Brunswick Streetscape Enhancement Project

ADDENDUM #1

Addendum # 1 responds to written questions received by prospective bidders, and one found discrepancy on the plans.

EX-3
SCALE: 1"=10'
DATE: JULY 20, 2023
PROJECT NO: 3516-11
OF 32
DWD: DESIGNED
GB: DRAWN
DWD: CHECKED
SHEET NAME: EX-3

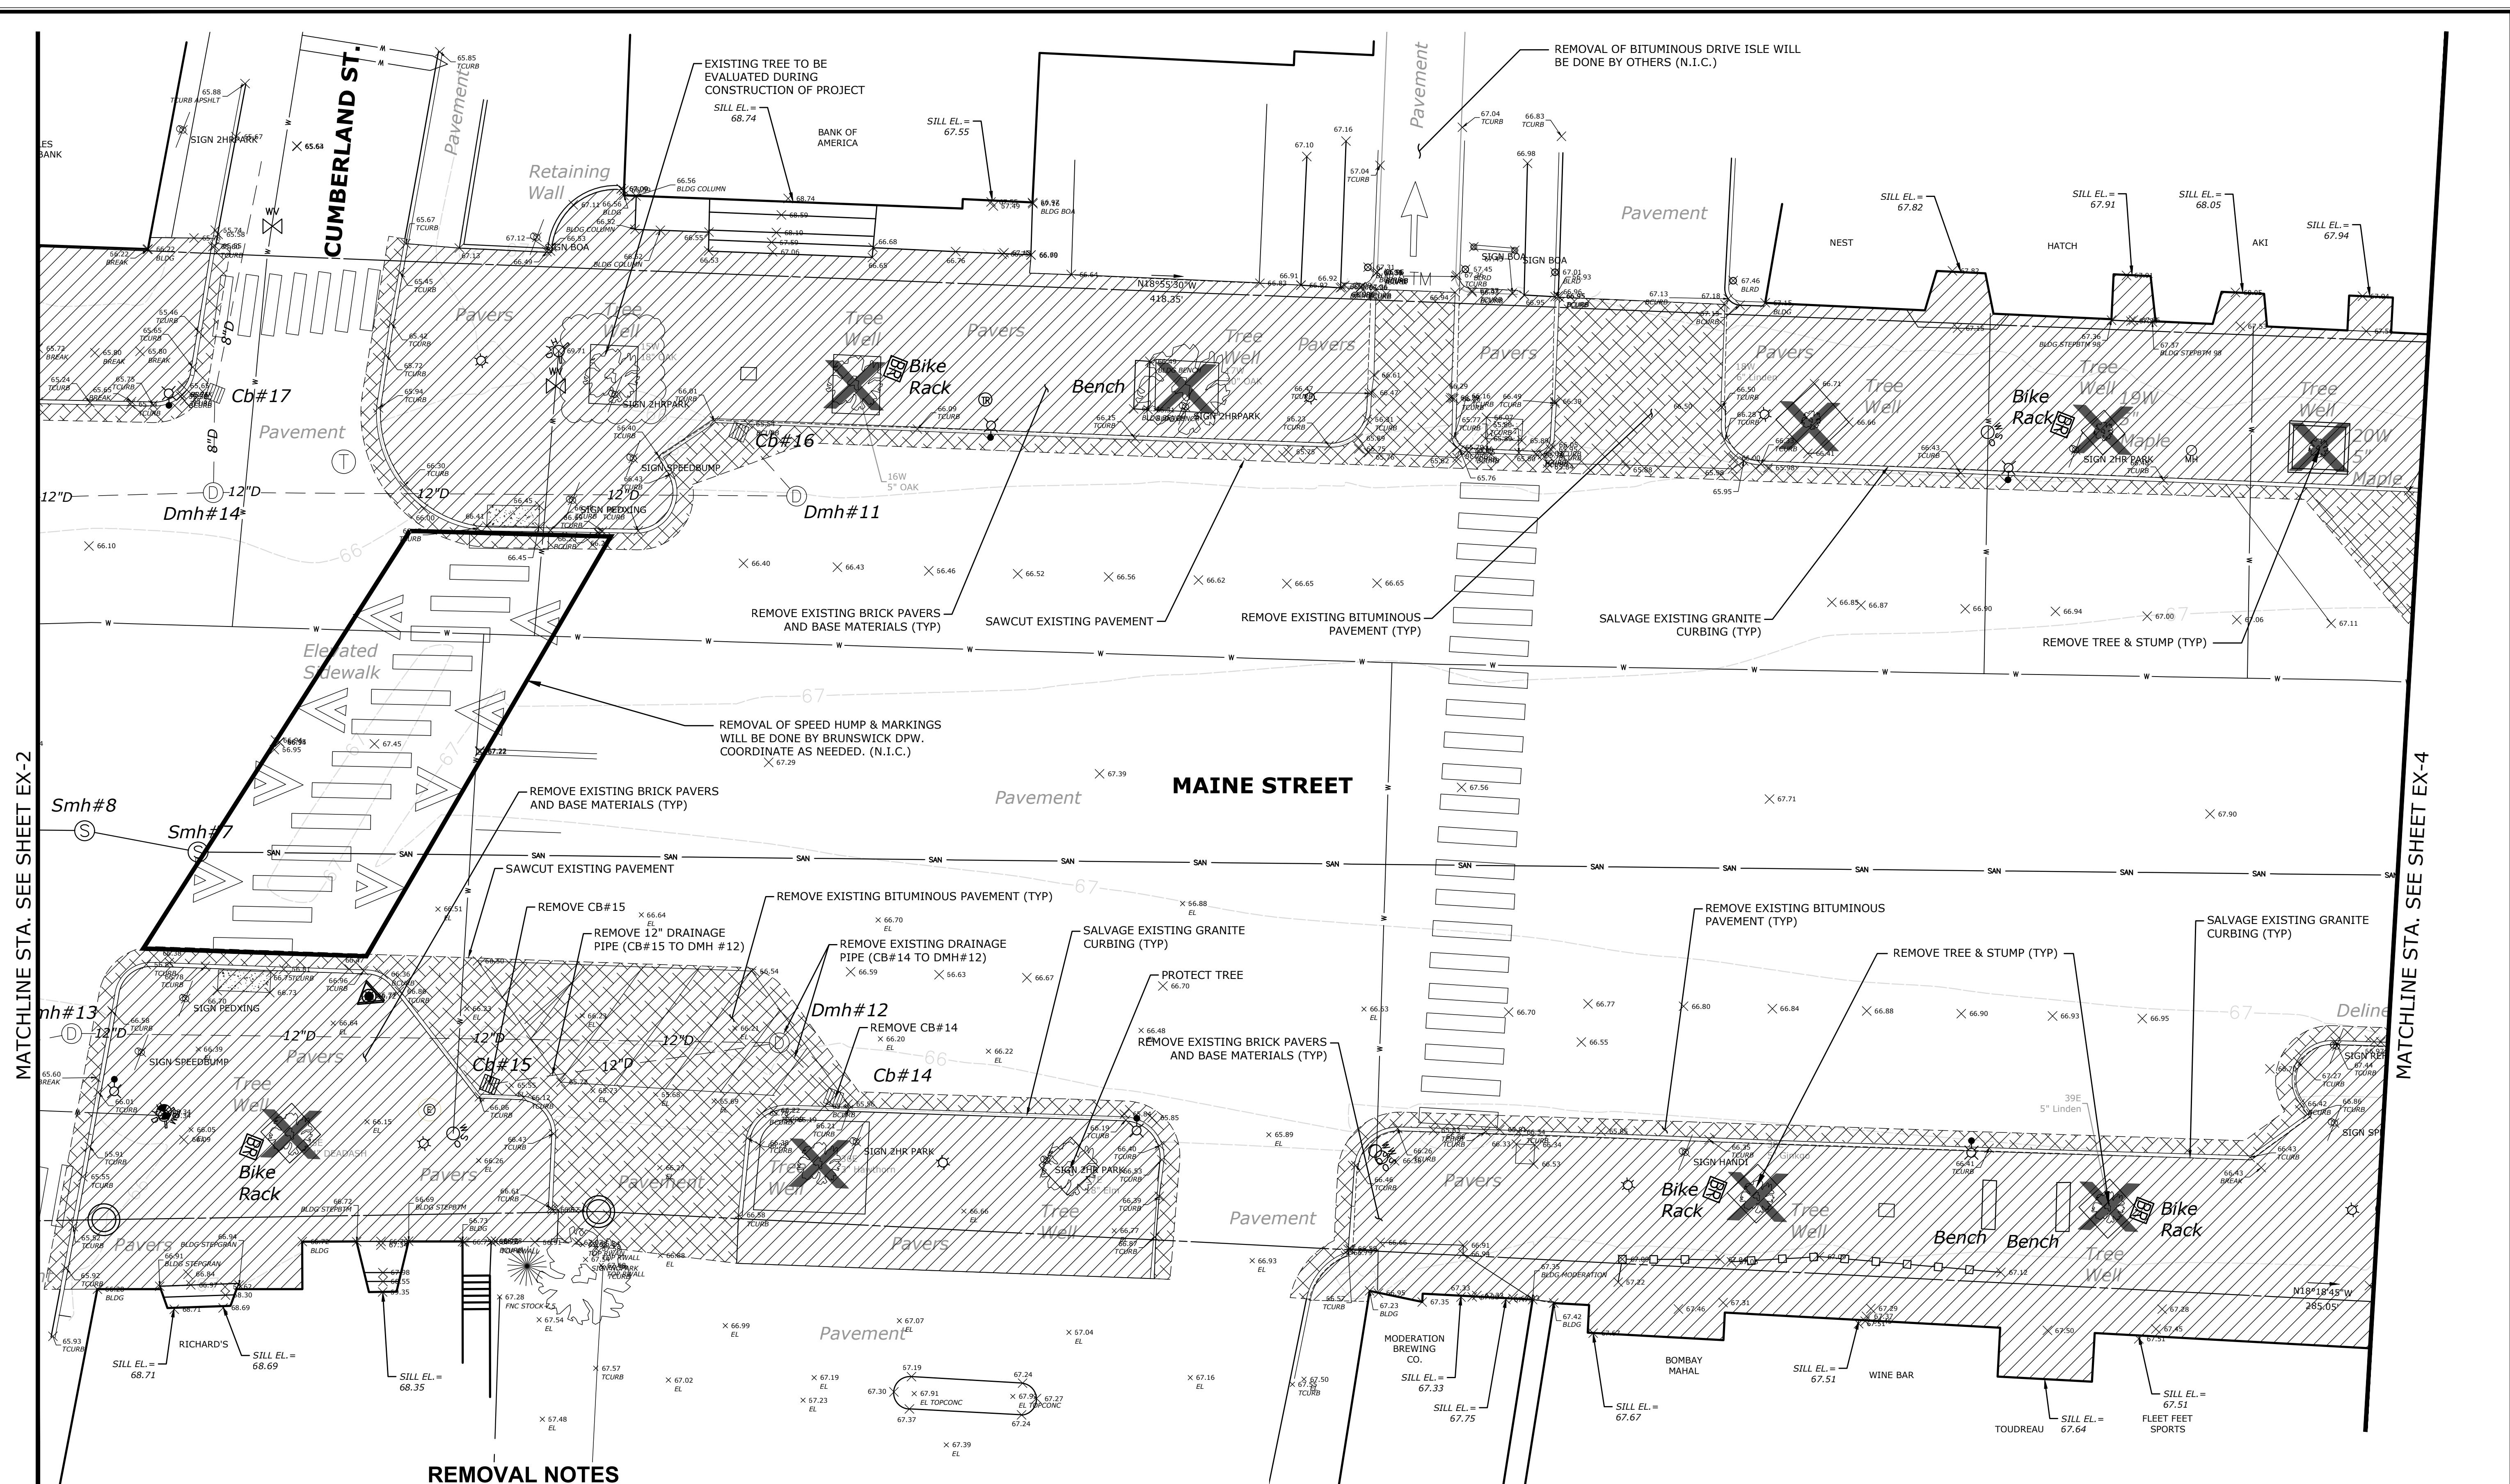
1. A revised Sheet EX-3 is provided. Please note that the 18" Oak Tree on the west side of Maine St nearest Cumberland St. (in front of Bank of America) is NOT being removed, initially. Contractors shall coordinate with the Town Arborist on the evaluation of this tree as shown on Sheet LM-4.
2. A revised Section 609 – Granite Curbing is attached. Please refer to Question #12 below.

SLR
DATE: 8-20-23
BY: DDS
DESCRIPTION: TREE EVALUATION CALL OUT
